OVERVIEW HILLS

AN ADDITION TO SEDGWICK COUNTY, KANSAS

RE: SUB 2001-51 -- Final Plat of Overview Hills Addition

CASE NUMBER: SUB 2001-51 -- OVERVIEW HILLS ADDITION

OVERVIEW HILLS
AN ADDITION TO SEDGWICK COUNTY, KANSAS

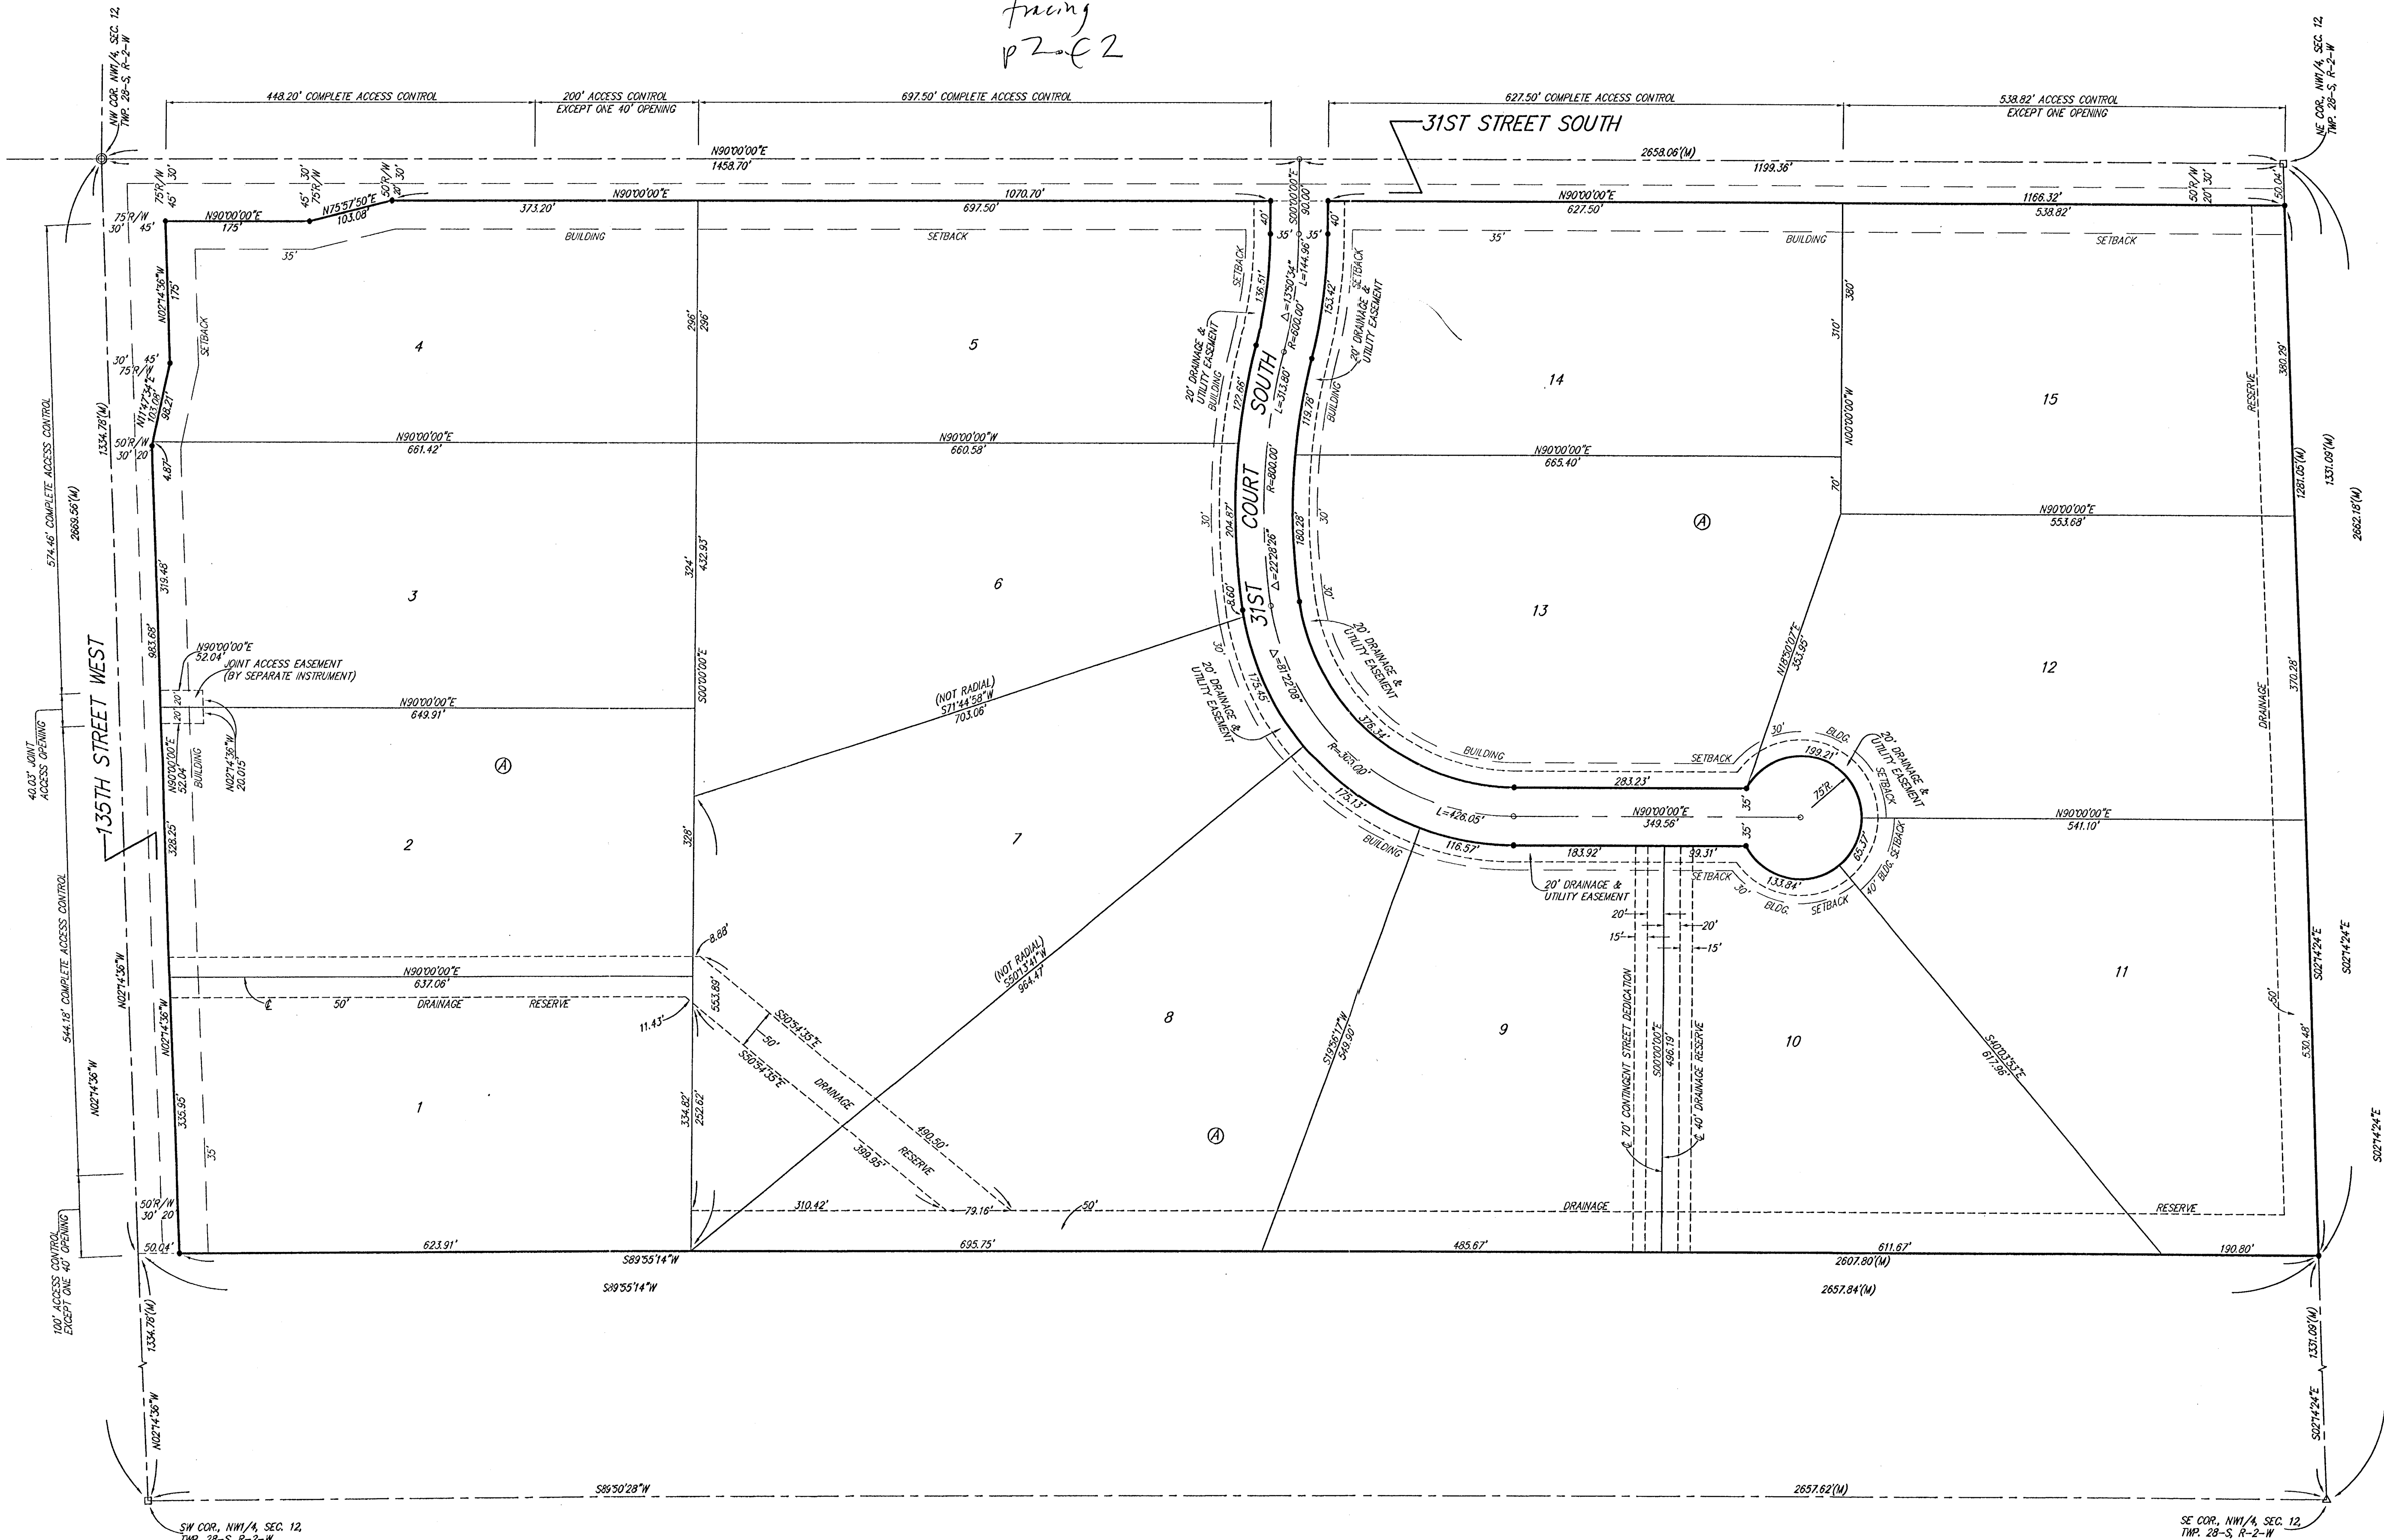
- F. County Engineering needs to comment on the access controls. The plat proposes two access openings along 31st St. South, and two openings along 135th St. West, including one joint opening. *The access controls are approved. The 40-ft joint access opening shall be specified.*

- H. The applicant shall guarantee the installation of the proposed streets to the 36-ft rock suburban street standard.
- I. On the final plat tracing, the contingent dedication of street right-of-way needs to be referenced in the plat's text as becoming effective upon the platting of any adjacent subdivision having a street connecting thereto.

- J. Approval of this plat will require a waiver of the lot depth to width ratio of the Subdivision Regulations for Lots 6, 7, 8, and 11. The Subdivision Regulations state that the maximum depth of all residential lots shall not exceed 2.5 times the width. The Subdivision Committee has approved the modification.

- M. Lot 11 may not meet the 100-ft lot width requirement which is measured at the building setback line. This dimension should be denoted on the final plat. An increase in the distance of the building setback from the road would meet the standard. The building setback has been increased to 40 feet.

- N. In the surveyor's certificate and the plat's text, the word "estates" needs to be removed.
- O. The centerline of 31st Street Court needs to be located along 31st St. South.

- P. The location and elevation of permanent on-site Bench Mark needs to be added.
- Q. The plat's text should be corrected to specify "an Addition to ...".
